### Re; Unit Plan 119 - Urambi Village

## Urambi Structures Application House 6

David Keightley (Structures Coordinator) House 55 (david@dara.com.au) 4 April 2017 Subject: RE: UP119 Unit 6A Urambi VIIge, Air Conditioner Application

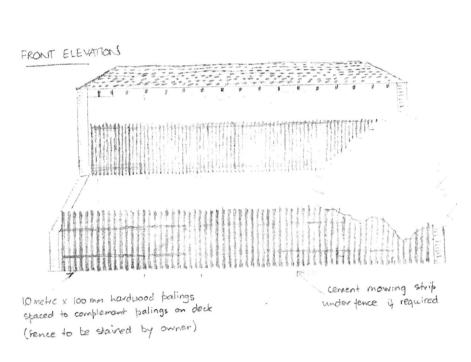
Body Conservate to himled as fewer at the bases of may have so that may day can dive auticle during the day.

I enclose a white of the terms I would like To have limit, while I keline would must the aesthetic argumentments of the Body Conservate and of Chambing generally. The ferre would lend itself to the alanting of andress.

I have not yet sawet the agreement of would be grateful if the Body Congress the would would be grateful if the Body Congress would would be grateful if the Body Congress would would consider the Morrosal, subject

to the meghbours' concert.

I am pleased to advise that the Urambi Village Body Corporate Committee has no objections to your proposal for a fence on the western edge of your unit entitlement. A copy of your proposal, so endorsed is attached.
